Re: Gym Parapet Wall Movement  
Linderman School  
Polson, MT.

Subject **GYM WALL STABILIZATION**

EXISTING SECTION

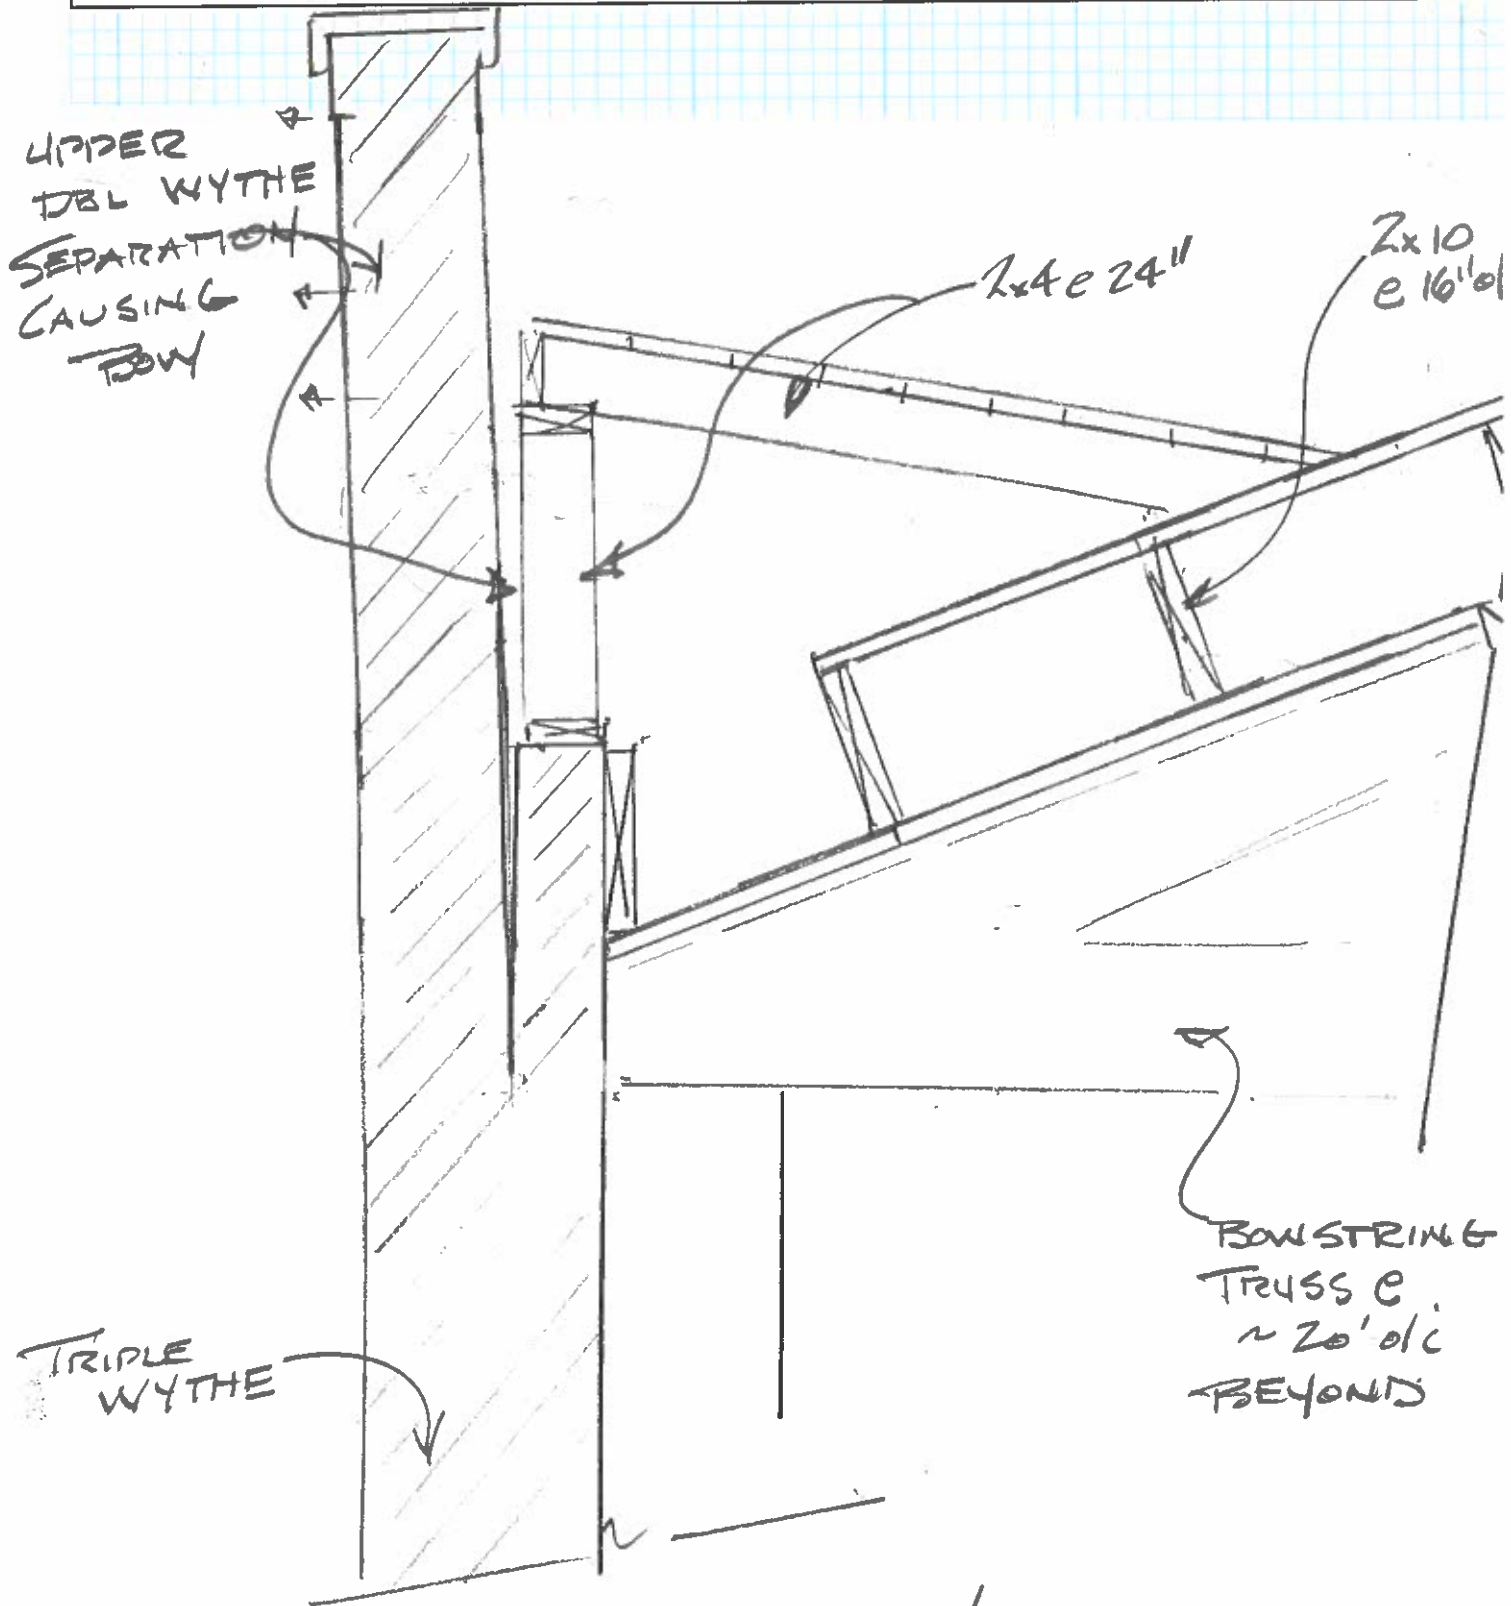
The gym wall is a triple wythe, unreinforced brick masonry (URM) wall to the level of the arched bowstring roof trusses and corresponding arched roof structure. Above the arched roof, the wall shifts to a double wythe wall. For a significant portion of the south wall, the double wythed, upper portion has shifted outward. Please see attached rough sketch A for reference to this condition. The cause is considered to be seasonal, cyclic drifting snow and ice against the wall. Further explanations have been generated by your office in earlier reports. This letter and sketches address a stabilization repair.

**B** REPAIR DETAIL

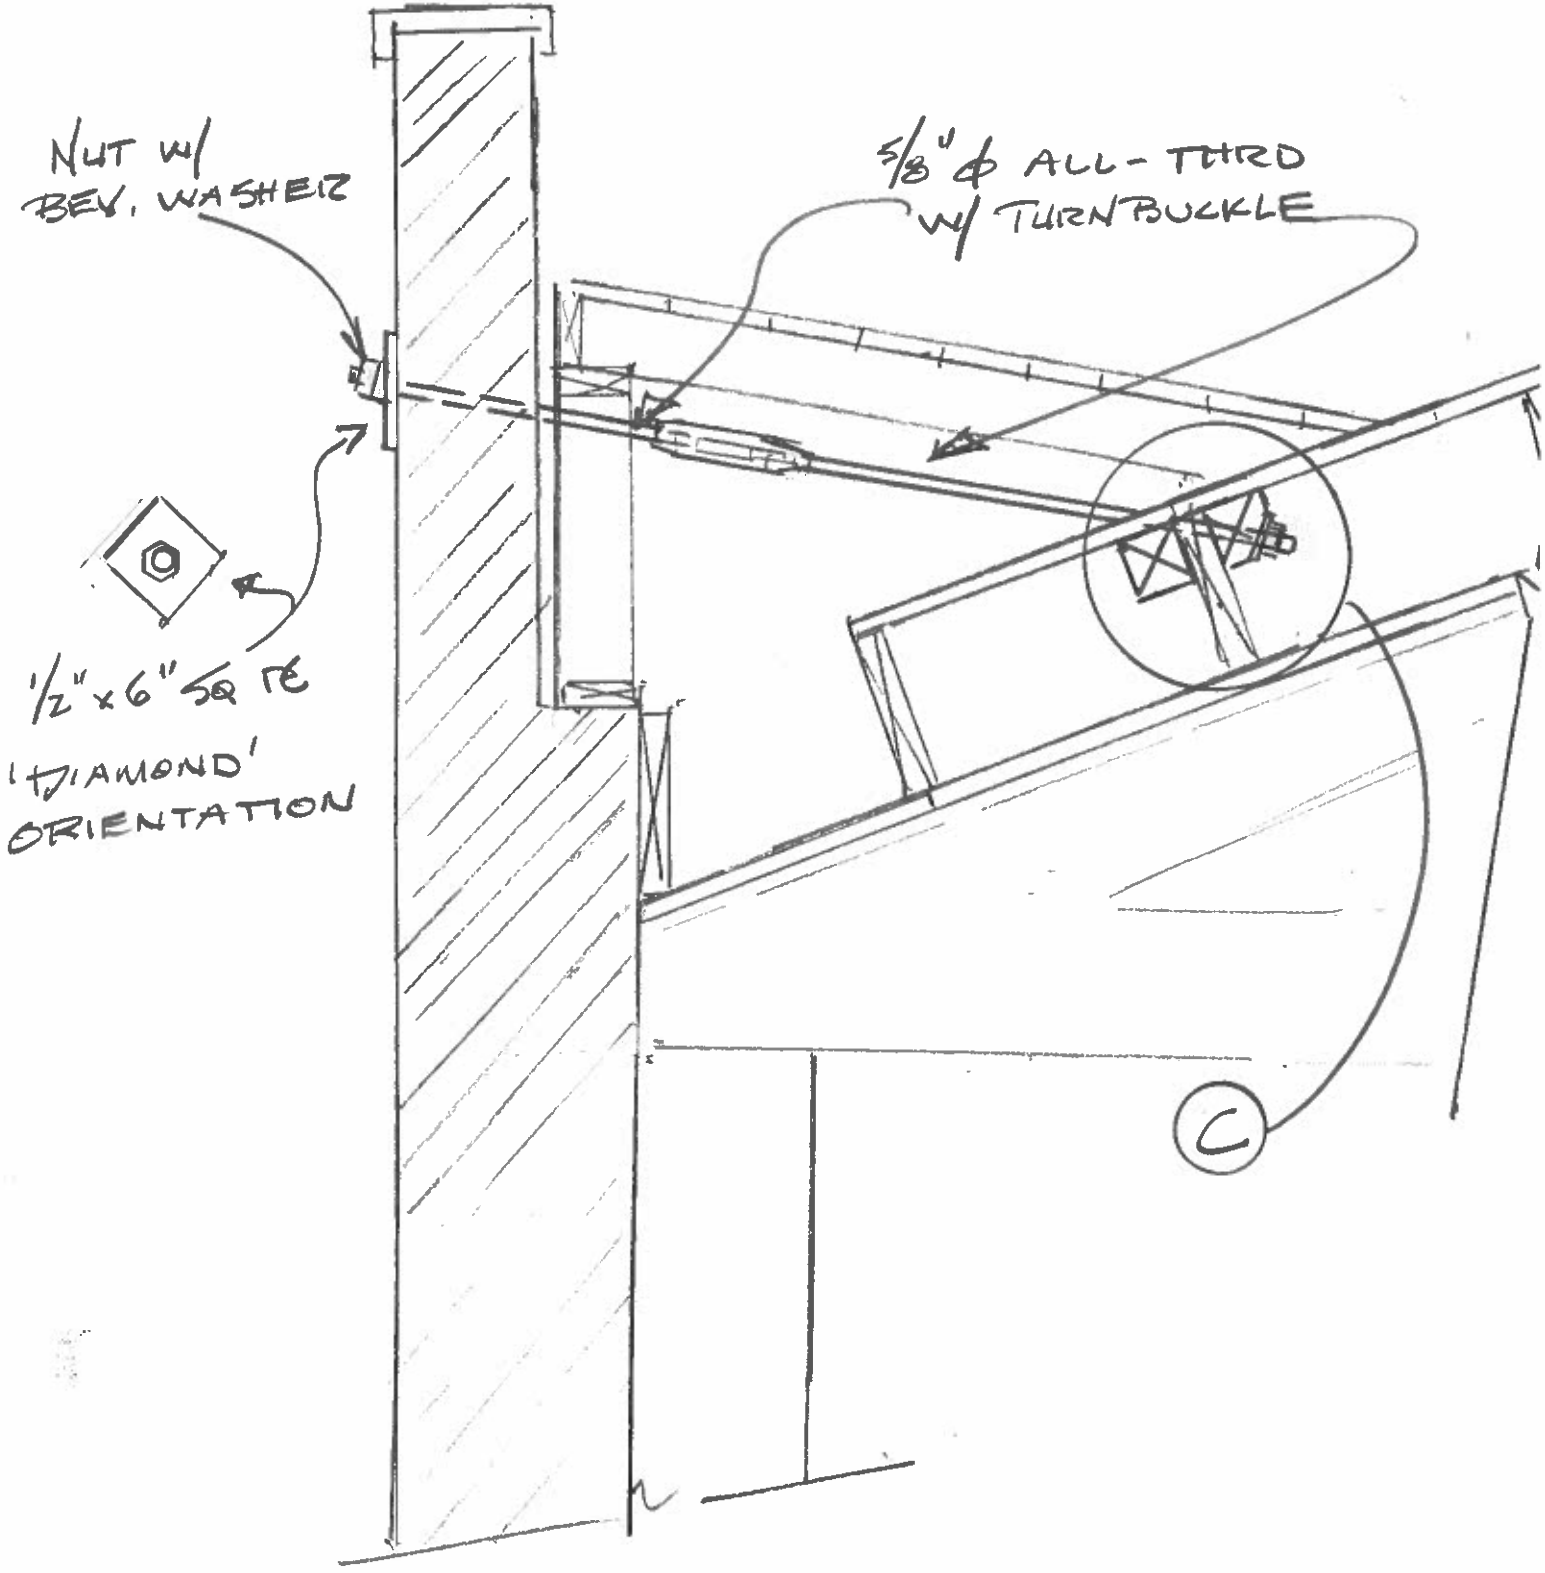
- For the tie-backs, please install all-tread bolts through the brick wall with face plates against the exterior face of the wall. Please reference attached detail B.

**C** BACK CONN.

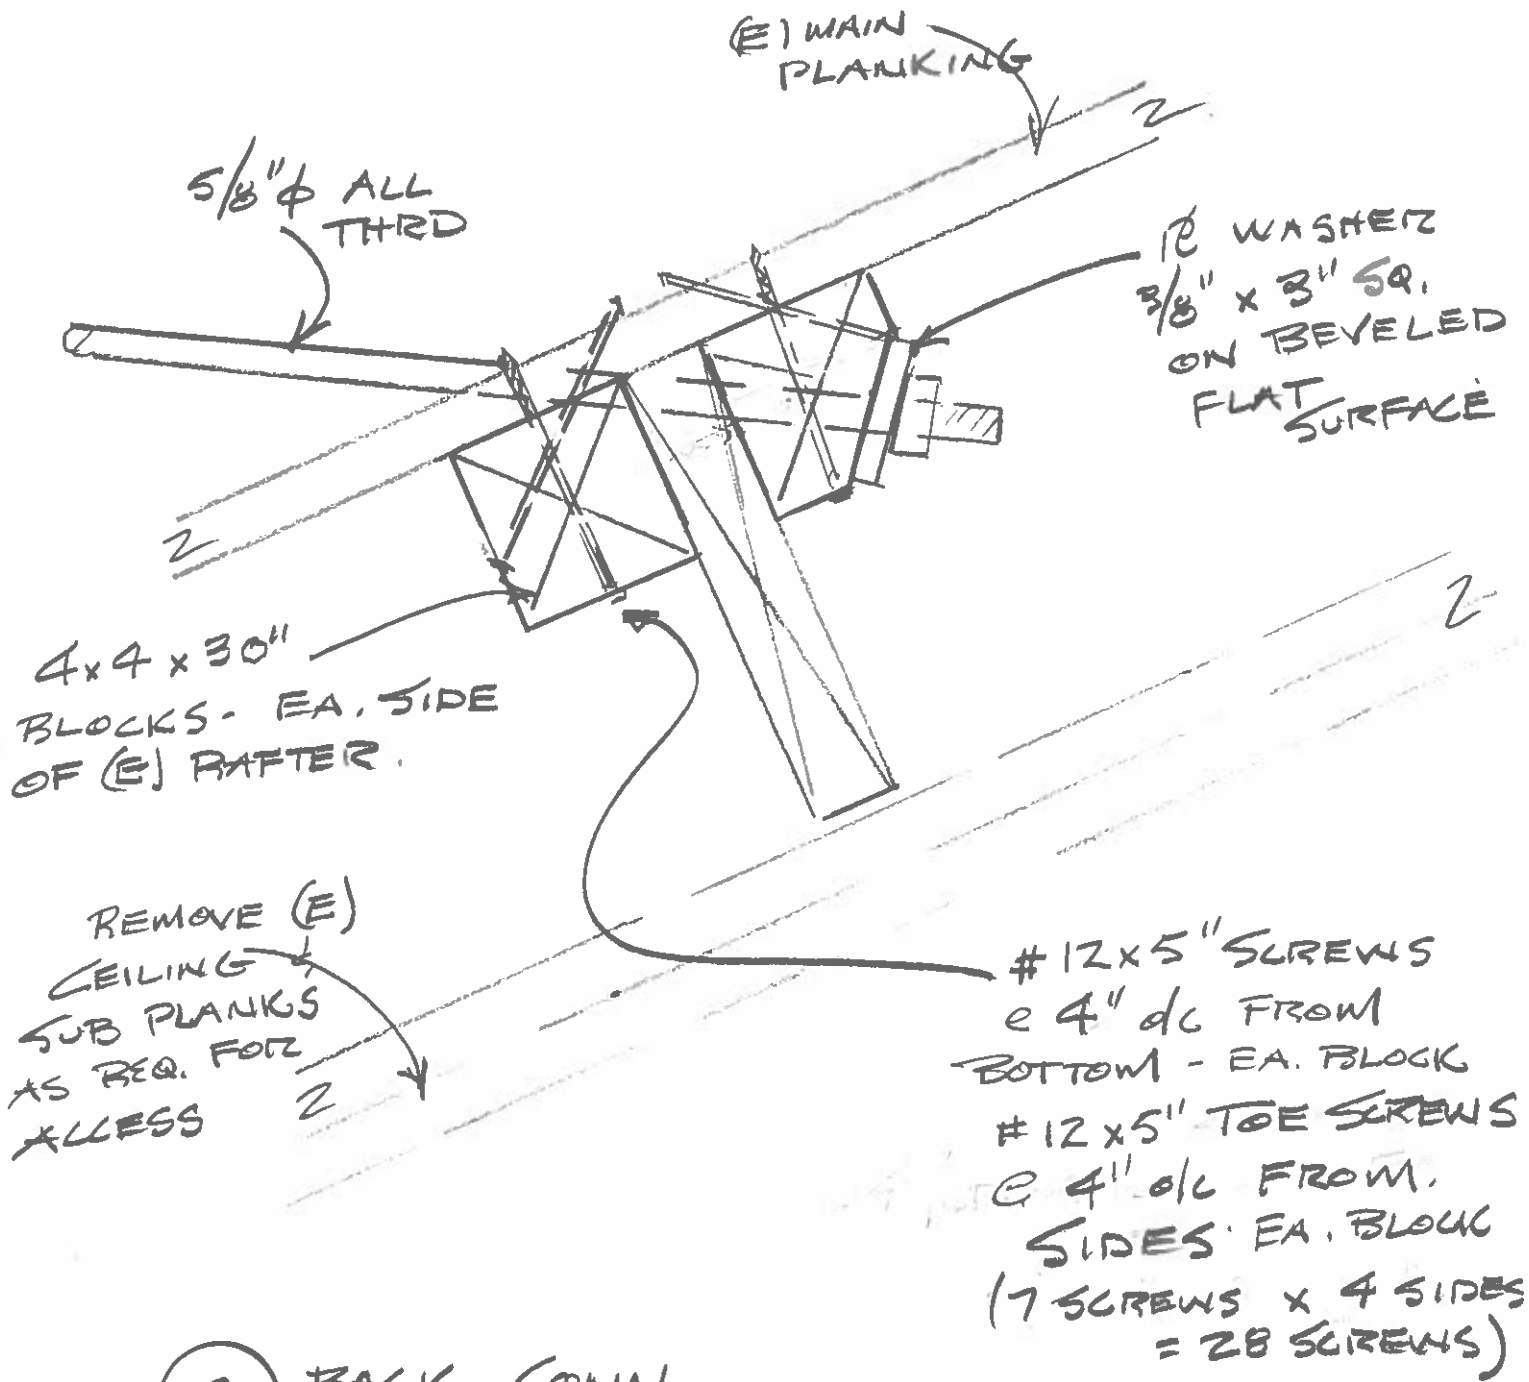
- Remove existing ceiling material to access the through bolt locations. Install anchor blocks against the existing rafter as shown in detail C.
- Extend a 5/8" diameter all-tread through the anchor blocks to connect to the wall through bolt with a turnbuckle.
